dsPIC33EPXXXGS70X/80X Family Silicon Errata and Data Sheet Clarification

The dsPIC33EPXXXGS70X/80X family devices that you have received conform functionally to the current Device Data Sheet (DS70005258B), except for the anomalies described in this document.

FIGURE 1: TIMING DIAGRAMS FOR CENTER-ALIGNED AND EDGE-ALIGNED MODES

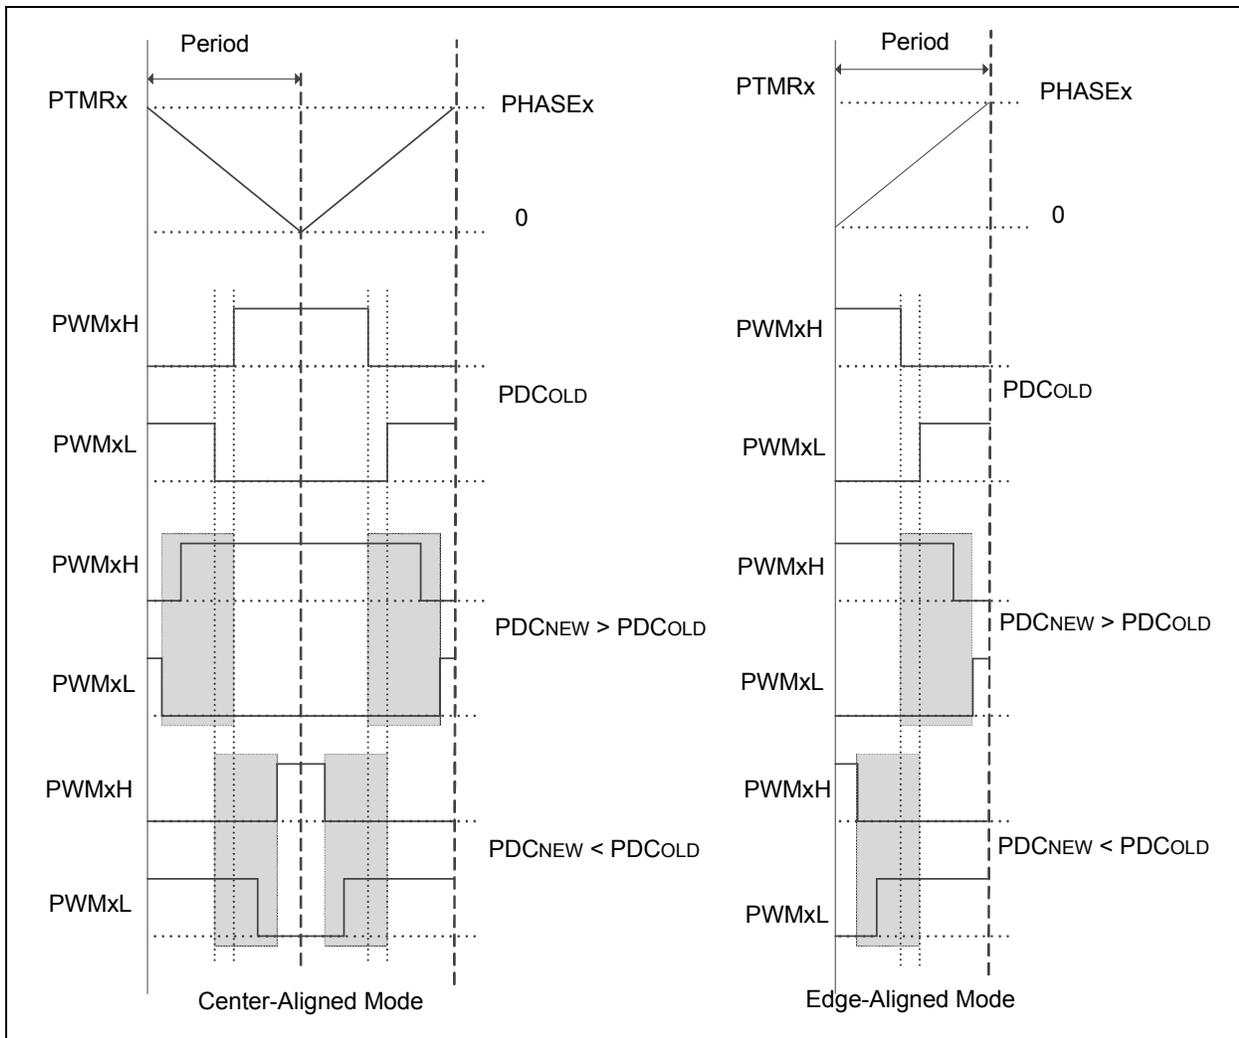
The PWMx generator may not assert dead time on the edges of transitions. This has been observed when all of the following conditions are present:

- The PWMx generator is configured to operate in Complementary mode with the Independent Time Base or Master Time Base
- Immediate Update is enabled
- The value in the PDCx register is updated in such a manner that the PWMxH and PWMxL outputs make an immediate transition

The current duty cycle, PDCOLD, newly calculated duty cycle, PDCNEW, and the point at which the write to the Duty Cycle register occurs within the PWMx time base, will determine if the PWMxH and PWMxL outputs make an immediate transition. PWMxH and PWMxL outputs make an immediate transition if the Duty Cycle register is written with a new value, PDCNEW, at a point of time when the PWMx time base is

counting a value that is in between PDCNEW and PDCOLD. Additionally, writing to the Duty Cycle register close to the instant of time where dead time is being applied may result in reduced dead time, effective on the PWMxH and PWMxL transition edges.

In Figure 1, if the duty cycle write occurred in the shaded box, then PWMxH and PWMxL will make an immediate transition without dead time.

None. However, in most applications, the duty cycle update timing can be controlled using the TRIGx trigger or Special Event Trigger to avoid the above mentioned conditions.

FIGURE 2:

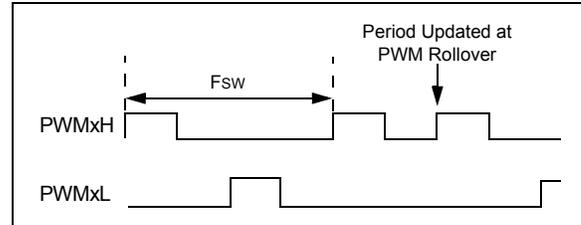
When the PWM module is configured for Push-Pull mode (IOCONx<11:10> = 0b10) with the Enable Immediate Period Update bit enabled (PTCON <10> = 1), a write to the Period register that coincides with the period rollover event may cause the push-pull output logic to produce back-to-back pulses on the PWMx pins (see Figure 2).

Ensure that the update to the PWM Period register occurs away from the PWM rollover event by setting the EIPU bit (PTCON<10> = 1). Use either the PWM Special Event Trigger (SEVTCMP) or the PWM Primary Trigger (TRIGx) to generate a PWM Interrupt Service Routine (ISR) near the start of the PWM cycle. This ISR will ensure that period writes do not occur near the PWM period rollover event.

FIGURE 3: EXAMPLE FOR REDUNDANT OUTPUT MODE

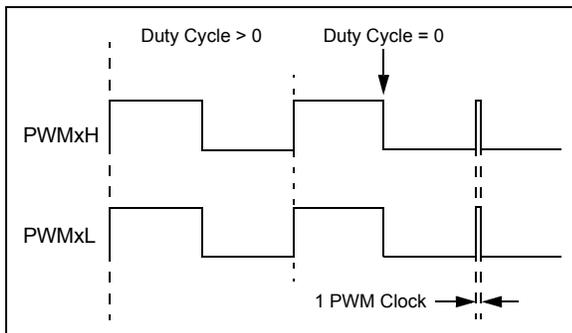
In the Redundant Output mode (IOCONx<11:10> = 0b01) and Push-Pull Output mode (IOCONx<11:10> = 0b10), with the Immediate Update Enable bit disabled (PWMCONx<0> = 0), when the Duty Cycle register is updated from a non-zero value to zero, a glitch pulse of a width equal to 1 PWM clock will appear at the next PWM period boundary, as shown in Figure 3 (for the Redundant Output mode). The Duty Cycle register refers to the PDCx register if PWMCONx<8> = 0 or the MDC register if PWMCONx<8> = 1.

If the application requires a zero duty cycle output, there are two possible work around methods:

1. Use the PWM override feature to override the PWM output to a low state instead of writing to the Duty Cycle register. In order to switch back to a non-zero duty cycle output, turn off the PWM override. The override-on and override-off events must be timed close to the PWM period boundary if the IOCONx register has been configured with IOCONx<0> = 0 (i.e., output overrides through the OVRDAT<1:0> bits occur on the next CPU clock boundary).
2. Enable the Immediate Update Enable bit (PWMCONx<0> = 1) while configuring the PWMx module (i.e., before enabling the PWMx module, PTCON<15> = 1). With the Immediate Update enabled, writes to the Duty Cycle register can have an immediate effect on the PWM output. Therefore, the duty cycle write operations must be timed close to the PWM period boundary in order to avoid distortions in the PWM output.
